United States Patent and Trademark Office

APPLICATION NO.	FILING DATE	FIRST NAMED INVENTOR	ATTORNEY DOCKET NO.	CONFIRMATION NO.	
10/730,894	12/10/2003	Ernesto Frassinelli	22106-00050-US	5198	
30678	7590 09/29/20	05	EXAM	EXAMINER	
	Y BOVE LODGE	WELCH,	WELCH, GARY L		
SUITE 800 1990 M STR	EET NW		ART UNIT	PAPER NUMBER	
WASHING?	TON, DC 20036-34	5	3765		
			DATE MAIL ED. 00/20/200	5

1170	
		Application No.	Applicant(s)		
Office Action Summany		10/730,894	FRASSINELLI, ERNES	STO	
	Office Action Summary	Examiner	Art Unit		
		Gary L. Welch	3765		
Period fo	The MAILING DATE of this communication a or Reply	appears on the cover sheet with	the correspondence addres	is	
WHI(- Exte after - If NC - Failu Any	ORTENED STATUTORY PERIOD FOR REPORTED IN CORP. STATUTORY PERIOD FOR REPORTED IN CORP. STATUTORY PERIOD FOR REPORTED IN CORP. STATUTORY DEPARTMENT OF THE MAILING IN CORP. STATUTORY DEPARTMENT OF THE MAILING THE	DATE OF THIS COMMUNICA 1.136(a). In no event, however, may a reply od will apply and will expire SIX (6) MONTH: tute, cause the application to become ABAN	TION. / be timely filed S from the mailing date of this commun DONED (35 U.S.C. § 133).		
Status

DETAILED ACTION

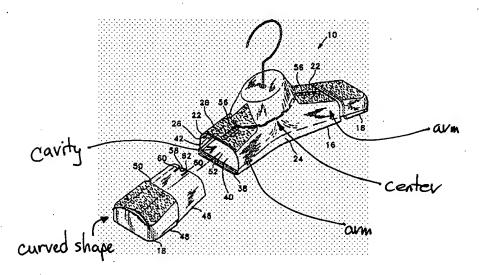
3. Claims 1-6 are rejected under 35 U.S.C. 102(b) as being anticipated by Long et al. (U.S. 5,718,358).

Long et al. discloses an adjustable clothes hanger 10 having upper hanging means 20, two symmetrical side arms 16 extending away from the center point of the hanger (see figure below) and moveable means 18 for supporting a garment. The moveable supporting means 18 are fixed integrally with sliding elements (56, 58) in cavities provided inside the arms so as to permit width adjustment of the moveable means 18.
